From: Kenny, Ann
Sent: Monday, August 06, 2001 11:06 AM
To: 'Elizabeth Leavitt'; 'Keith Smith'; 'Wendy Clement'; 'Michael Cheyne'; 'Paul Fendt'
Cc: Hellwig, Raymond
Subject: FW: Sea-Tac Third Runway: NHC Comments on Port of Seattle's New Low Streamflow Analysis

August 6, 2001

Re: Port of Seattle July 23, 2001 Low Streamflow Analysis

As you know, Northwest Hydraulic Consultants has been retained on behalf of the Airport Communities Coalition (ACC) to provide a technical review of stormwater facilities and related streamflow impacts from the proposed 3rd runway development at SeaTac airport. The purpose of this letter is to comment on the July 23, 2001 Port of Seattle two-volume document titled "Low Flow Analysis Flow Offset Facility Proposal." The comments here are in addition to the outstanding Stormwater Management Plan issues and uncertainties described in our letter of June 25, 2001, and summarized at our meeting on July 10, 2001.

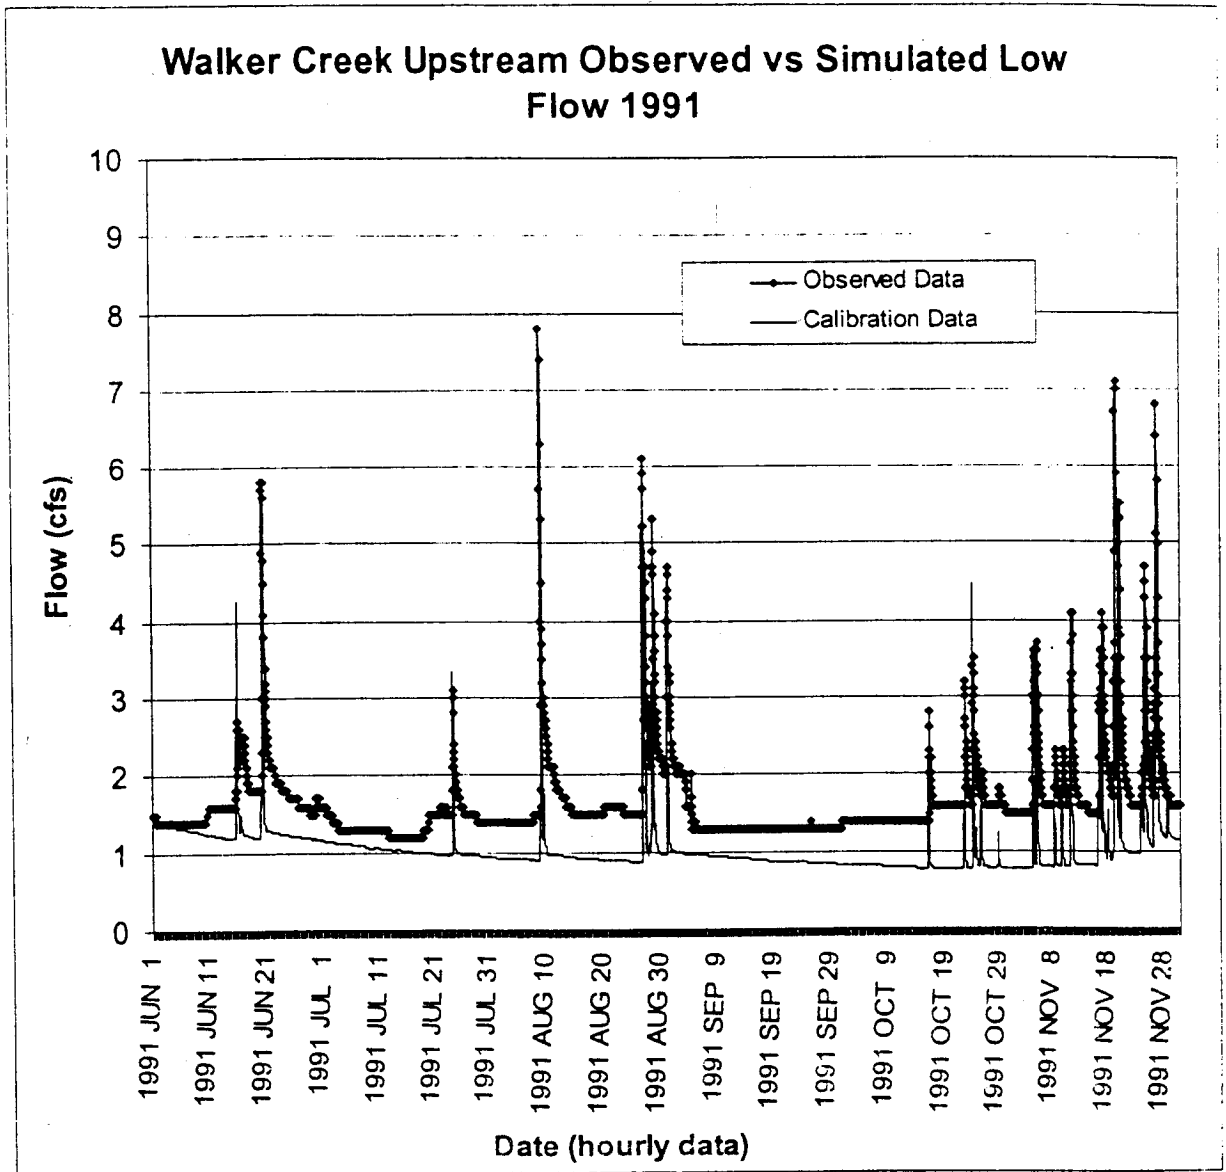
4. The magnitude of dry-period transit losses from the storage facilities to the streams needs to be examined and accounted for at all reserve storage facilities. In particular, if flow paths include open ditches, then seepage losses (to groundwater or to supply transpiration by bank vegetation) could be significant and would need to be accounted for. If flow paths are via dispersal or infiltration systems which are set back some distance from the stream or which provide wetland recharge, then transpiration losses could be significant and would need to be accounted for. An evaluation of transpiration losses should examine the flow path and estimate the acres of soils that are hydraulically connected to the flow path. This would be a function of topography as well as soil type. Such an analysis should include the effects of routing low flows through storage facilities such as the Miller Creek Detention Facility. The magnitude of transit losses by plant transpiration, assuming grass, would be in the order of one inch per week. At this rate, transit losses of 0.1 cfs (representing approximately the total amount of reserve storage flow for each stream) would occur if the flow path were hydraulically connected to about 17 acres of vegetation. The Miller Creek

Detention Facility may provide the opportunity for a hydraulic connection and transit losses of this magnitude.

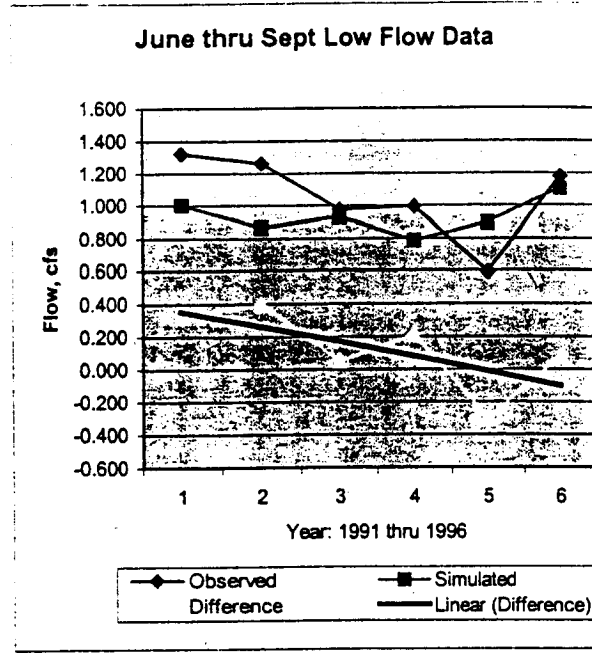
6. For Walker Creek, the calibration of simulated (HSPF) low flows to recorded low flows at the upper basin gage is very poor. HSPF simulation results for all calibration years (1991-1996) produce base flows which become progressively smaller from June through October, with the lowest flows of the year generally occurring in October. These simulation results formed the basis for the low flow analysis report finding that the summer low flow period for Walker Creek begins on August 1 and ends on October 31. However, this pattern and definition of low flow period is inconsistent with the actual streamflow record. The recorded data show that the lowest flows of the year actually occurred in June and/or July in half of the years with recorded data. In our opinion, definition of the low flow period should rely more on the actual data and less on the model data given that the calibration is so poor. Visual inspection of the recorded streamflow data for 1991-1996 suggests that the season where low flows are of concern should be extended to cover at least the period of July 1 through October 31. A comparison of Walker Creek simulated and recorded streamflows for 1991 is given in the figure below to illustrate the basis for this comment.

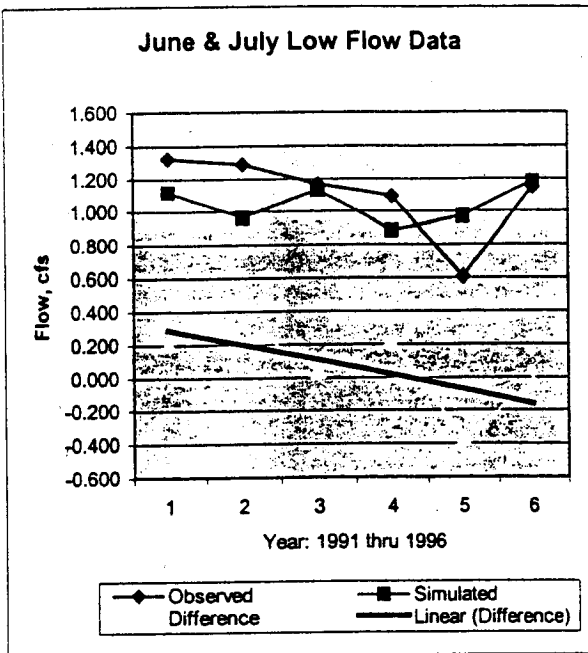
then differences between the recorded and simulated data for other years could indicate changes in basin conditions. We examined the average summer low flow at the upper basin gage for each year of record, to see if the recorded (actual) flows were changing relative to the simulated flows. For this evaluation, days with observed and/or computed flows greater than 1.5 cfs (representing surface runoff) were excluded from the calculation of average summer low flows. Average value for simulated and recorded low flows were computed for each year, and plotted as a time series. The results are shown below.

We have two alternative interpretations of these results. One interpretation is that there is a pronounced declining trend in the observed data relative to the simulated data for the same period. The analysis shows that summer streamflows are declining independent of climatic variability, and that there has been an average summer low flow reduction of about 0.5 cfs over the period 1991 to 1996. The alternative interpretation is that the Walker Creek HSPF model calibration to low flows, in conjunction with uncertainty as to the quality of observed streamflow data, is too poor to draw any conclusions about anything. Under the first interpretation, the proposed low streamflow mitigation of 0.09 cfs for Walker Creek is probably insufficient to compensate for actual airport impacts. Under the second interpretation, there is substantial uncertainty as to whether the HSPF model is useful for assessing low streamflow impacts or devising a mitigation plan for Walker Creek.
